GPS RWY 8

**U.S. DEPARTMENT OF TRANSPORTATION
FEDERAL AVIATION ADMINISTRATION
CATEGORICAL EXCLUSION DECLARATION**

**Santa Ynez Airport
Santa Ynez, California**

**GPS RWY 8 (Amend)
GPS A (Amend)
VOR OR GPS B (Amend)**

Figure 1 – RNAV (GPS) RWY 8

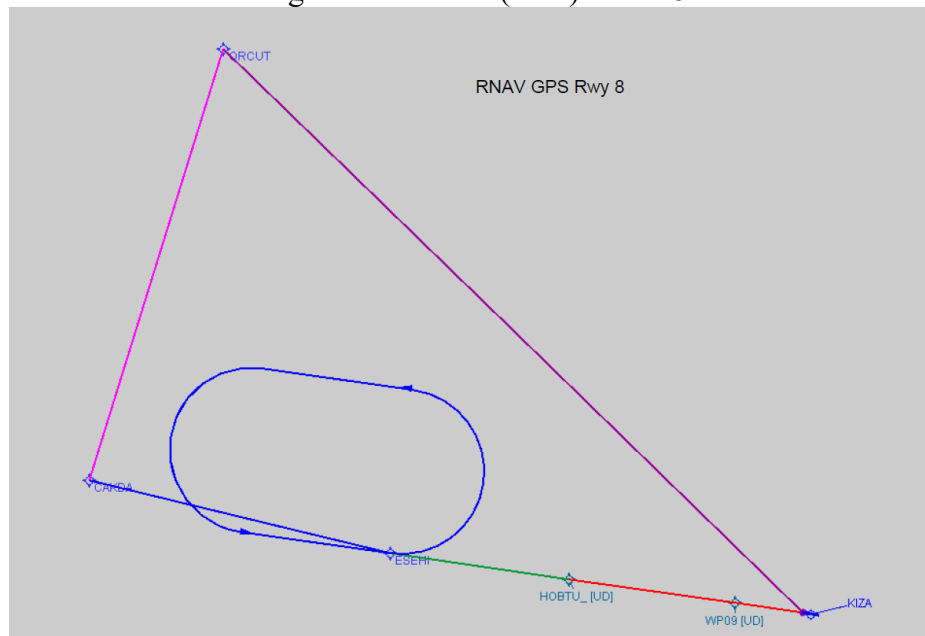
Procedure Name	Proposed Amendments
RNAV (GPS) RWY 8 <div>ORCUT - CADKA EXCEEDS 90 TURN CRITERIA. REPLACE ORCUT - ESEHI</div> <div>BAWDY = WP09</div>	<ul style="list-style-type: none"> Minimum altitude on the feeder route from ORCUT Waypoint (WP) to CAKDA Initial Approach Fix (IAF) would decrease from 5,700 feet Mean Sea Level (MSL) to 3,600 feet MSL. Minimum altitude at the hold-in-lieu of pattern at ESEHI IAF would decrease from 4,000 feet MSL to 3,600 feet MSL. HOBTU Final Approach Fix (FAF) would be relocated .22 Nautical Miles (NM) west to 34°37'19.8136"N/120°12'16.3752"W. Minimum altitude from ESEHI IAF to HOBTU FAF would decrease from 2,900 feet MSL to 2,800 feet MSL. A new Step-Down Fix (SDF), WP09, would be added along the final approach course after HOBTU FAF, 1.81 NM west of the runway threshold, with a minimum crossing altitude of 1,300 feet MSL.
RNAV (GPS) A <div>LEMMA = WP49 INTERM SDF</div>	<ul style="list-style-type: none"> A new SDF, WP49, would be added 5.3 NM west-northwest of San Marcus (RZS) Very High Frequency Omni-Directional Radio Range Tactical Air Navigation (VORTAC) at

Figure 2 – RNAV (GPS) A

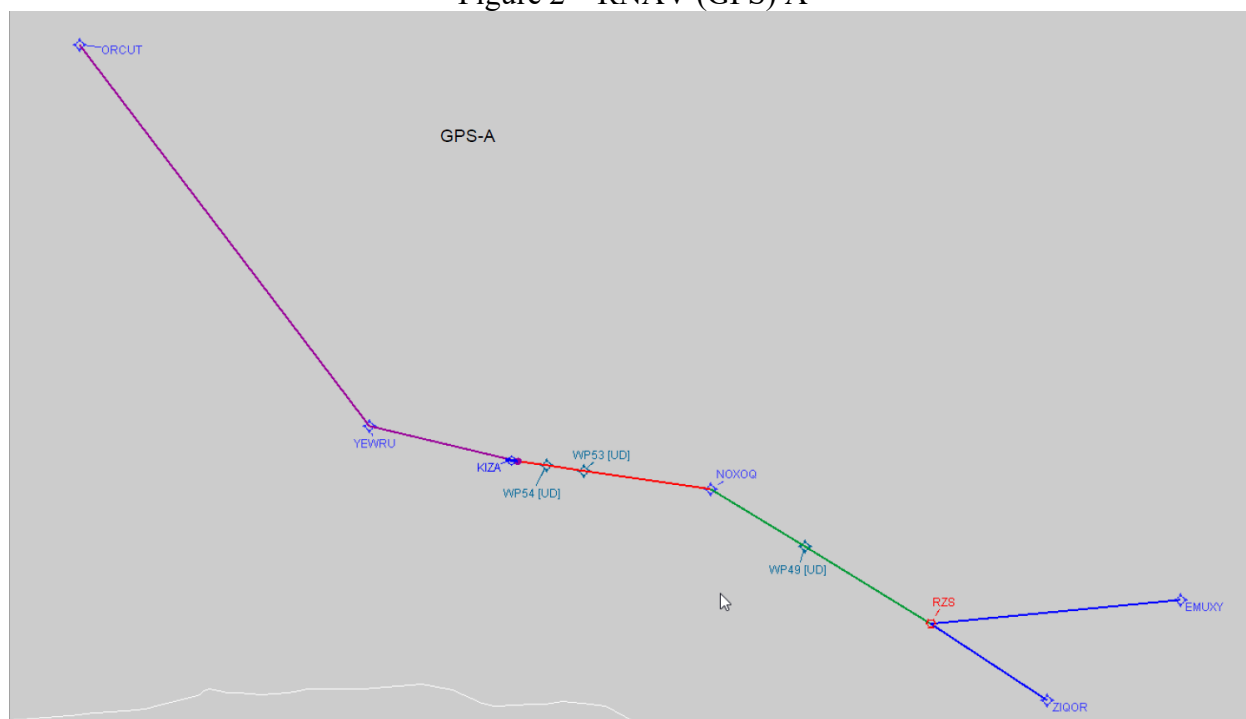
<p>34°33'18.9750"N/119°51'45.0669"W. Minimum altitude from RZS VORTAC to WP49 would be 4,400 feet MSL, and minimum altitude from WP49 to NOXOQ FAF would be 3,400 feet MSL.</p> <ul style="list-style-type: none"> • Circling visibility minimum for Category B aircraft would increase from 1.5 NM to 1.7 NM.
<p>VOR RWY 8</p> <p>DOWWN = WP586 INITIAL SDF</p>	<ul style="list-style-type: none"> • CALLI intersection would be relocated .12 NM south of current location to 34°38'4.7079"N/120°10'0.9420"W and function as both an IAF and a Precision Final Approach Fix (PFAF). • Minimum altitude on the initial segment from Gaviota (GVO) VORTAC to CALLI IAF would increase from 5,000 feet MSL to 6,000 feet MSL. • A new SDF, WP586, would be added 12 NM west of RZS VORTAC on the initial segment from RZS VORTAC to CALLI IAF at 34°34'52.2525"N/119°59'49.5453"W. Minimum altitude from RZS VORTAC to WP586 would be 6,500 feet MSL, and minimum altitude from WP586 to CALLI IAF would be 6,000 feet MSL. • Procedure Turn (PT) completion altitude would decrease from 3,500 feet MSL to 3,200 feet MSL. • Altitude on the intermediate segment from PT completion inbound to CALLI PFAF would decrease from 3,000 feet MSL to 2,700 feet MSL. • The final approach segment would be changed from RZS radial (R)277.34 to RZS R277.02 to better align the final approach path with the landing threshold (the reason for CALLI relocation). • Circling visibility minimum for Category B aircraft would increase from 1.5 NM to 1.7 NM.
